Airworthiness Criteria: Airship Design Criteria for Zeppelin Luftschifftechnik GmbH Model LZ N07 Airship

ACTION: Notice of issuance of final design criteria.

Figure 3: Dihedral Angles for Position Lights

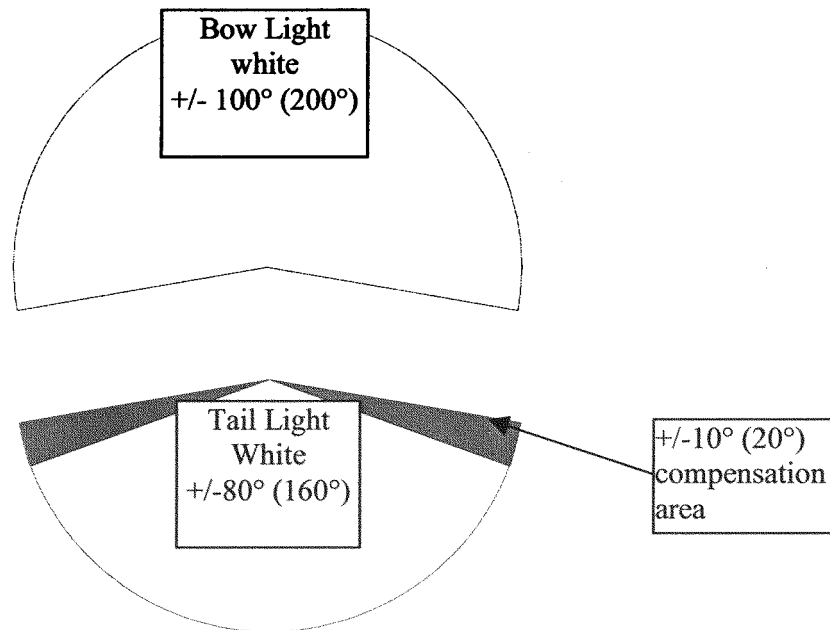
LFLS Section 2498(b) and ADC paragraph 6.25 specify the position lighting requirements for airships. It is not understood why a dispensation should be given for something that can be easily fixed with properly TSO’d LED or similar lighting. ABC had to go through a stringent certification of the lighting on the one model. This was revisited in a new model and the FAA

asked ABC to modify our position lighting by providing two sets of bow lights in slightly different positions to further ensure adequate brilliance in all sectors. It is not understood why any latitude is being given to this basic legal requirement affecting safe navigation of aircraft.

The FAA notes that there is no LFLS section 2498(b) and that the comparable LFLS section to ADC section 6.25 is LFLS section 1385. The only section where an equivalent level of safety to the LFLS lighting requirements was granted by the LBA is LFLS section 1387(b). The LBA granted this equivalency based on what was considered compensating features of the lighting system installed on the LZ N07-100, and the FAA agreed.

LFLS § 1387(b) requires a dihedral angle formed by two intersecting vertical planes making angles of 110 degrees to the right and to the left. LFLS appendix table 10 requires, in addition, a minimum light intensity of 20 cd throughout the dihedral angle. The LZ-N07 system only attains the required intensity over 100 degrees but is still visible from 100 degrees to 110 degrees (left and right) at a reduced intensity. The LBNA granted an equivalency to LFLS § 1387(b) based on the greater dihedral angle coverage of the aft light, +/-80 degrees rather than +/-70 degrees at the specified intensity. This is acceptable to the FAA.

The LFLS § 1387(b) required dihedral angle will be no less than 100 degrees at the intensities specified in Table 10 of the appendix of the LFLS. In addition, the rear light will have an included angle of +/-80 degrees at the specified intensity from Table 10 of the appendix of the LFLS. Refer to Figure 3.
